PAINT BRUSH HILLS FILING 13E

CONSTRUCTION PLANS

(WITH EARLY GRADING SUBMITTAL)

PAINT BRUSH HILLS FILING 13E CONSTRUCTION PLANS			
TITLE SHEET			
DESIGNED BY	MAW	SCALE	DATE 3-6-18
DRAWN BY	MAW	(H) 1"= N/A	SHEET 1 OF 28
CHECKED BY		(V) 1"= N/A	JOB NO. 2053.50

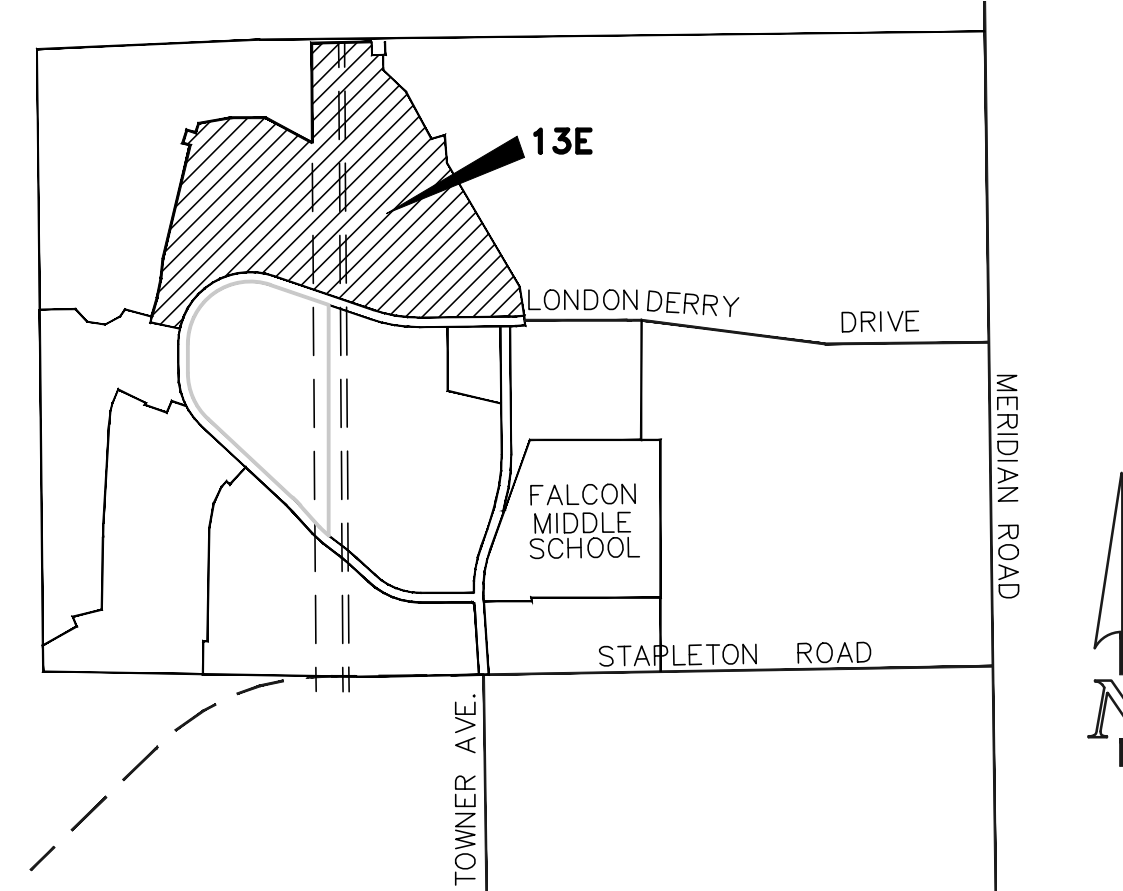
Revise title to designate these construction plans are for the utility plans

Add as a 3rd paragraph:
In accordance with ECM Section 1.12, these construction documents will be valid for construction for a period of 2 years from the date signed by the El Paso County Engineer. If construction has not started within those 2 years, the plans will need to be resubmitted for approval, including payment of review fees at the Planning and Community Development Directors discretion.

PAINT BRUSH HILLS FILING 13C CONSTRUCTION PLANS SHEET INDEX			
DESIGNED BY	MAW	SCALE	DATE
DRAWN BY	MAW	(H) 1" = 200'	SHEET 2 OF 28
CHECKED BY		(V) 1" = N/A	JOB NO. 2053.50

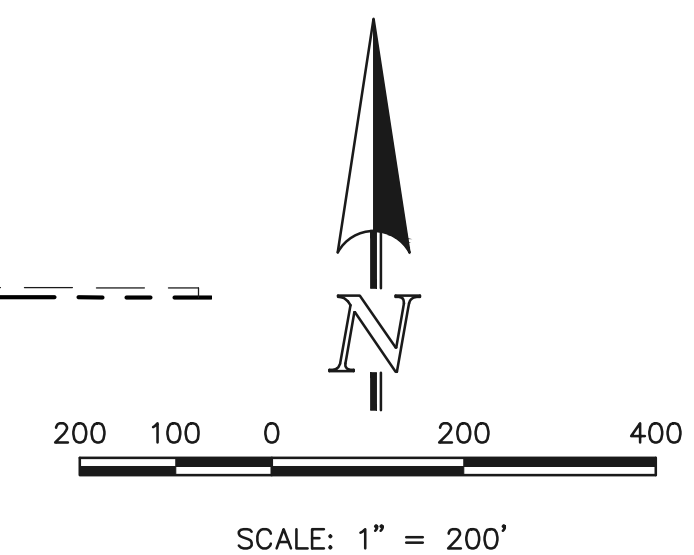
CDR185 is for a predevelopment grading request with installation of wet utilities. The only plans that should be in this construction drawings are the water system plan and utility service plan.

Remove all sidewalk exhibits, street improvement plans, storm sewer plans and detention plans. These will be reviewed for approval with the Filing 13E plat application. Alternative is to identify on each sheet that it's reference only and not a part of the approved plan set. Clearly note that the street designs are for reference only on the street improvement plans.

Remove and update the sheet numbering

Utility plan construction details are missing. Example: Typical trench & bedding detail, Fire Hydrant assembly, tracer wire detail, etc.

PAINT BRUSH HILLS FILING 13E
CONSTRUCTION PLANS
WATER SYSTEM PLANS
WATER LOWERING DETAILS

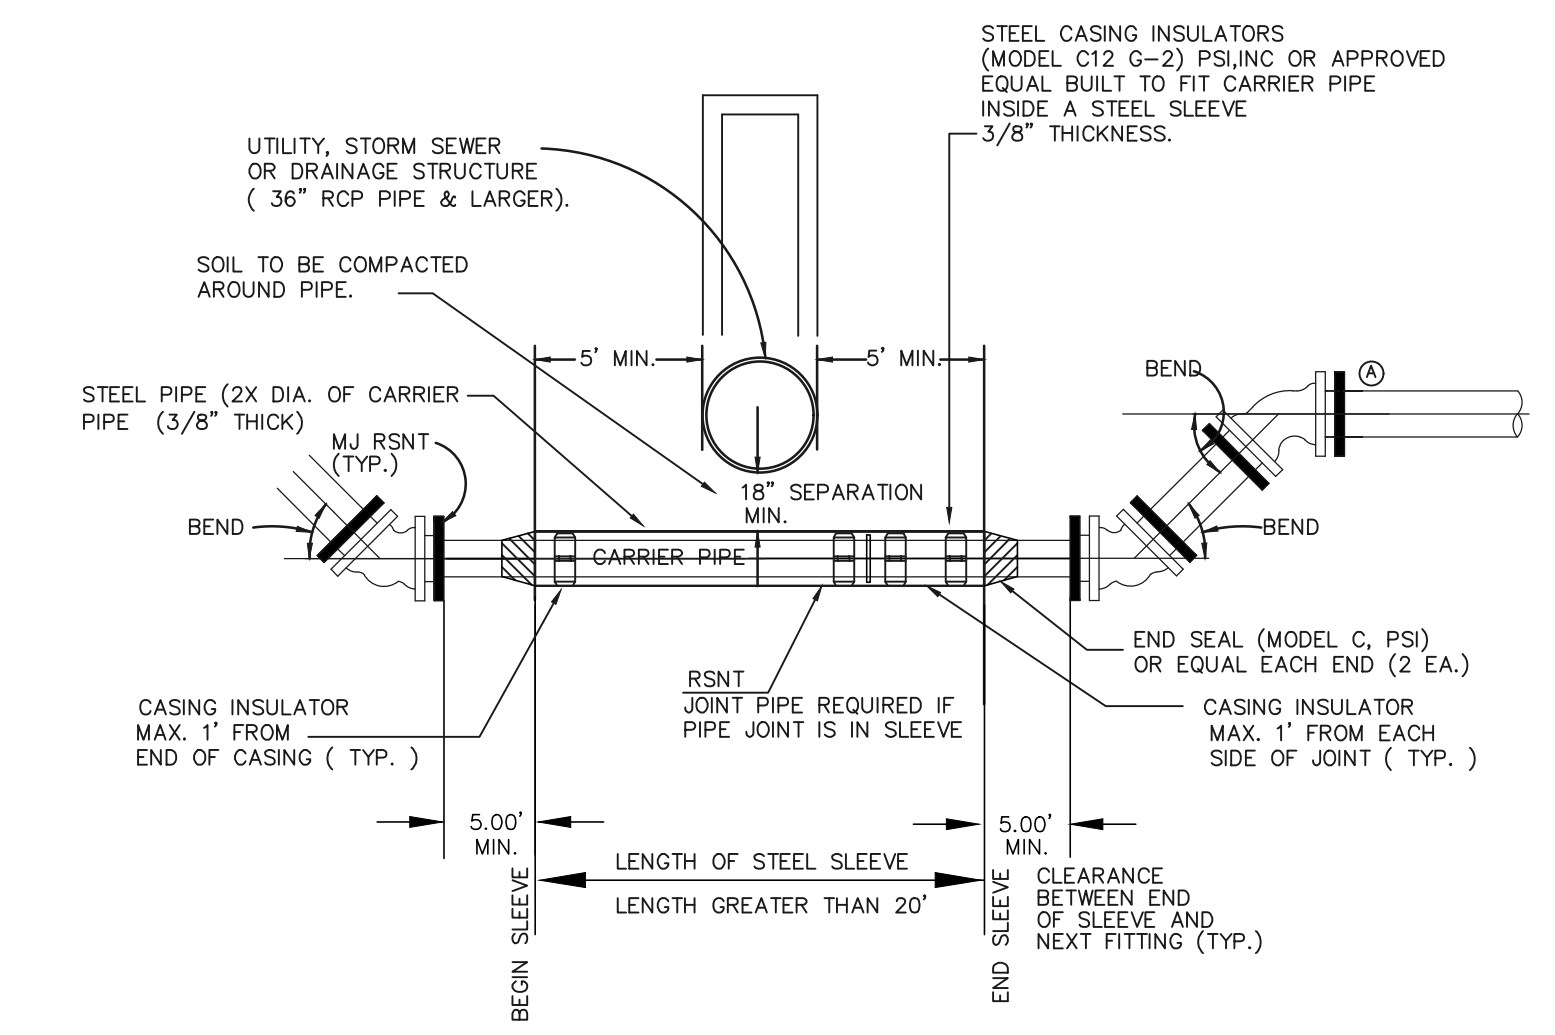
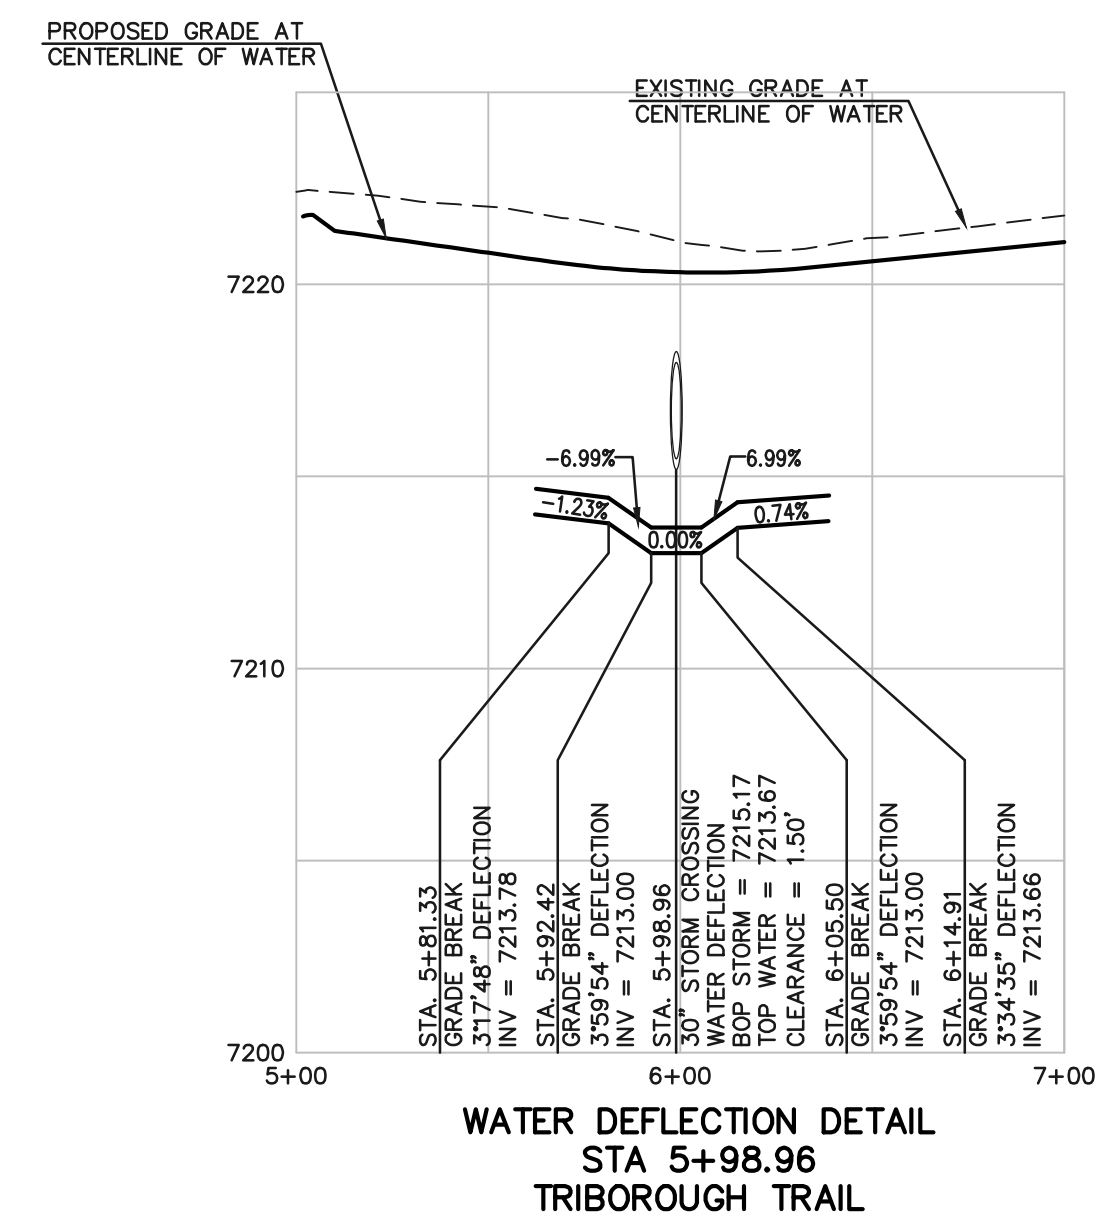
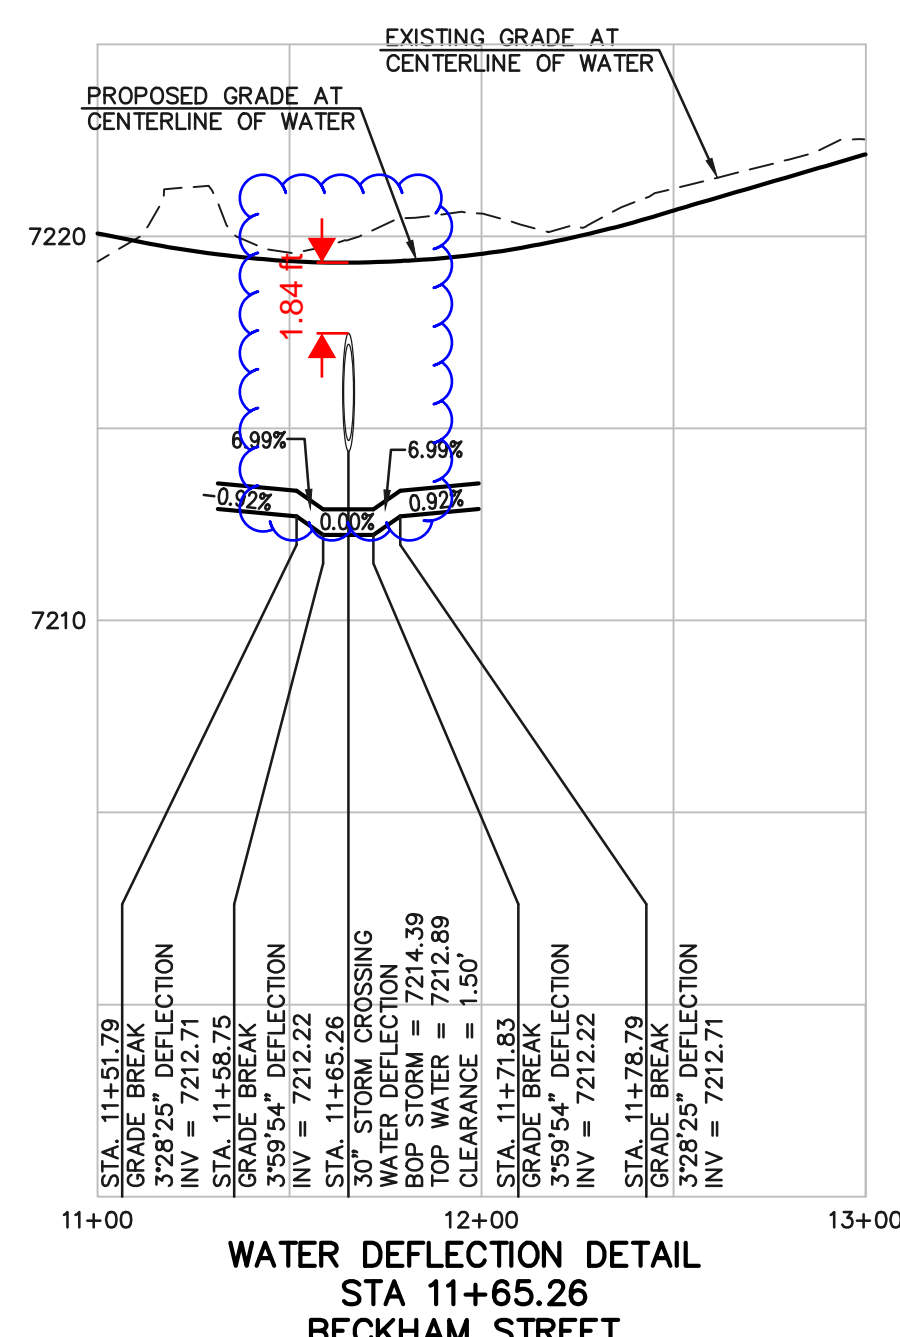
FYI: ECM 4.3.6.A.3 "At no time shall storm sewer lines be placed less than 2' in depth measured perpendicular to the finished road surface."
Adjust the stormline and water lowering to meet vertical clearances.
